**TIE-LINE 637 WOOD-TO-STEEL PROJECT**  
**MINOR PROJECT REFINEMENT**  
**REQUEST FORM**

<b>Date Requested:</b>	May 22, 2014	<b>Report #:</b>	008
<b>Date Approved:</b>	June 2, 2014	<b>Approval Agency:</b>	No other agency approval is required.
<b>Property Owner(s):</b>	Private and SDG&E Right-of-Way (ROW).	<b>Location/Milepost:</b>	Stringing Site Nos. 14 and 15
<b>Land Use/ Vegetative Cover:</b>	The proposed impact area occurs primarily within disturbed and non-disturbed coastal sage scrub habitat.	<b>Sensitive Resources:</b>	Sensitive habitats including Coastal Sage Scrub.
<b>Refinement / Modification From</b> (check all that apply):			
<input type="checkbox"/> Permit	<input type="checkbox"/> Plan/Procedure	<input type="checkbox"/> Specification	<input type="checkbox"/> Drawing
<input checked="" type="checkbox"/> Other: Stringing Site Modification			
San Diego Gas & Electric Company (SDG&E) is proposing to utilize a different temporary workspace for Stringing Site No. 14 (SS-14), located near Structure No. P100, and Stringing Site No. 15 (SS-15), located between Structure Nos. P100 and P101, than the workspace area that was originally described within SDG&E's application for a Per

Figure 1: MPR Overview Map

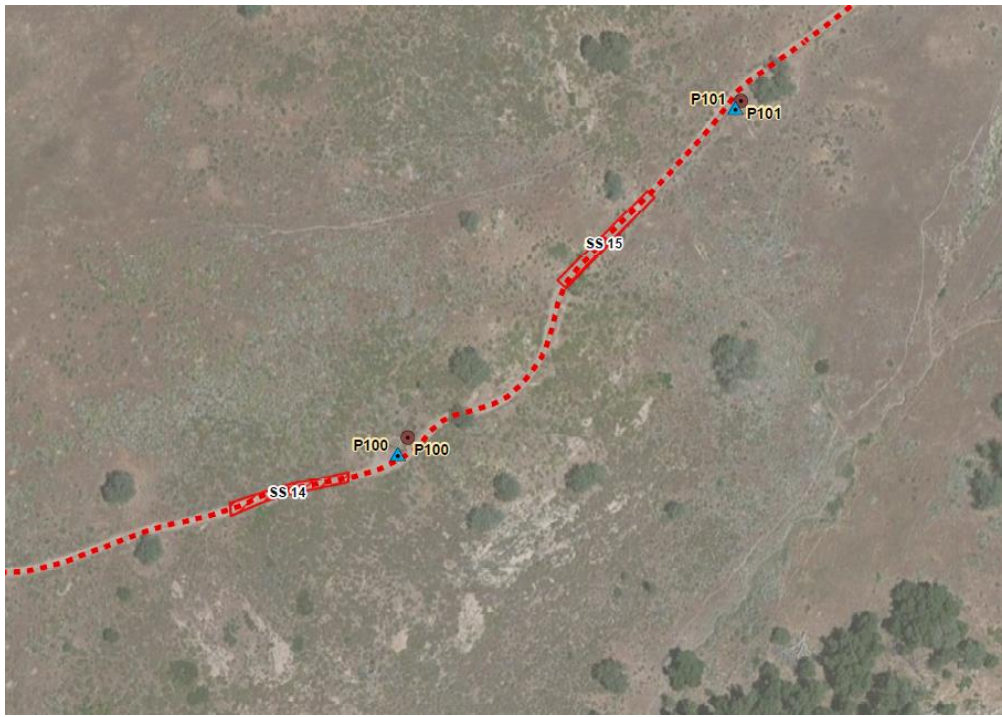
<b>Description of Refinement</b>			
SDG&E proposes to use a different temporary workspace area for SS-14 and SS-15, near Structure No. P100 in order to safely and successfully conduct stringing activities. The proposed modification shifts the stringing sites off of the existing access road onto the north side of the road, and modifies the configurations to trapezoid shapes. The modified SS-14 area is approximately 46 feet by 73 feet (average length and width) and will result in approximately 3,391 square feet of temporary impacts to coastal sage scrub habitat. The modified SS-15 area is approximately 32 feet by 54 feet and will result in approximately 1,668 square feet of temporary impacts to disturbed coastal sage scrub habitat. The original SS-14 and SS-15 temporary workspace areas would have resulted in a total of approximately 4,200 square feet (14 feet by 150 feet for each site) of temporary impacts (see Figure 1).

The previously contemplated temporary workspace areas for SS-14 and SS-15 would have resulted in a total disturbance area of approximately 4,200 square feet (150 feet long by 14 feet wide for both locations) adjacent to Structure No. P100 (refer to Figure 1).

Figure 2: Aerial image of proposed Stringing Site Nos. 14 and 15 modification.

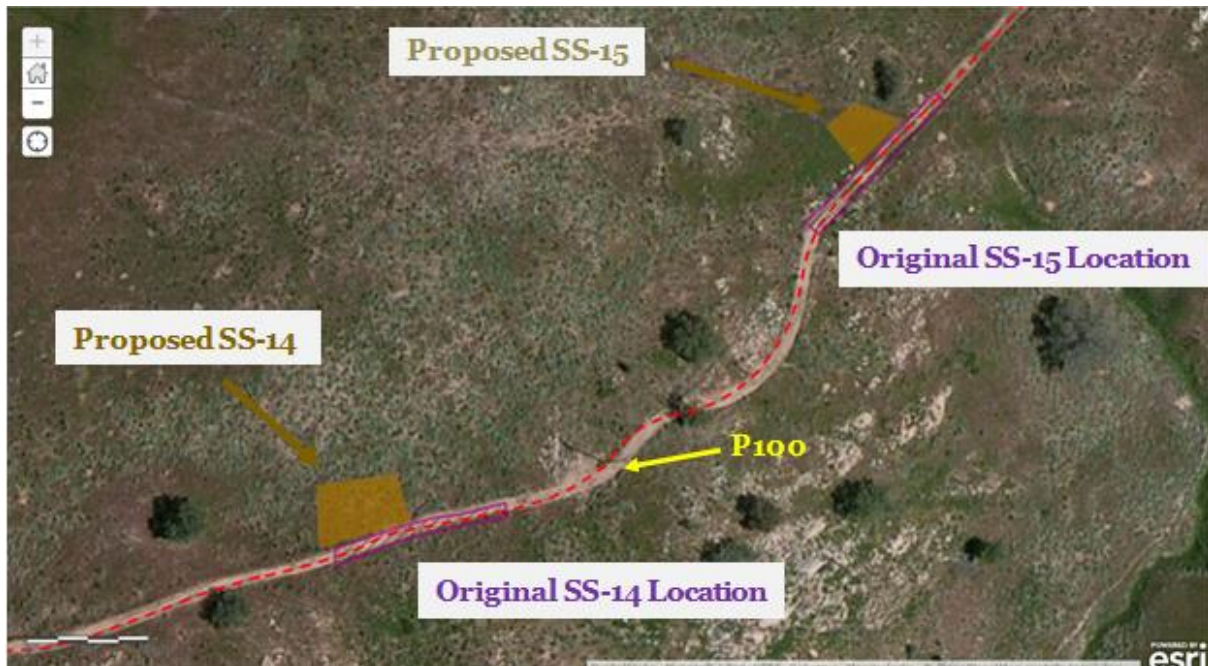
Figure 2 depicts the proposed new temporary workspace for SS-14 and SS-15 and the original SS-14 and SS-15 locations within the existing access road. Photograph Nos. 1 and 2 depict the proposed new temporary workspace area for SS-14. Photograph No. 3 depicts the proposed new temporary workspace area for SS-15.			
<b>Original Condition:</b>			
SS-14 and SS-15 were originally planned to be located within two discrete 14 foot by 150 foot areas located entirely within the existing access road adjacent to Structure No. P100 (refer to Figure 1).			
<b>Justification for Change:</b>			
Following in-field review of the stringing sites, construction crews identified potential logistical and safety concerns with utilizing the originally planned temporary workspace areas for SS-14 and SS-15 (refer to Figure 1). The original location of SS-14 and SS-15 occurs within the main access road; and in order to maintain clear access roads in the event of an emergency as well as maintain an unobstructed aerial path to safely pull conductor, the stringing sites need to be moved off the road. The modified SS-14 and SS-15 temporary workspace areas are advantageous over using the existing SS-14 and SS-15 locations because they are safer to use in the event of an emergency, and the

The proposed new temporary workspace area for SS-14 is anticipated to result in a disturbance area of approximately 3,391 square feet (approximately 73 feet long [average] by 46 feet wide [average]) as shown in Figure 2. The proposed new temporary workspace area for SS-15 is anticipated to result in a disturbance area of approximately 1,668 square feet (54 feet long by 32 feet wide) as shown in Figure 2. This would result in an additional disturbance area of approximately 859 square feet from the original area as a result of the proposed construction activities.
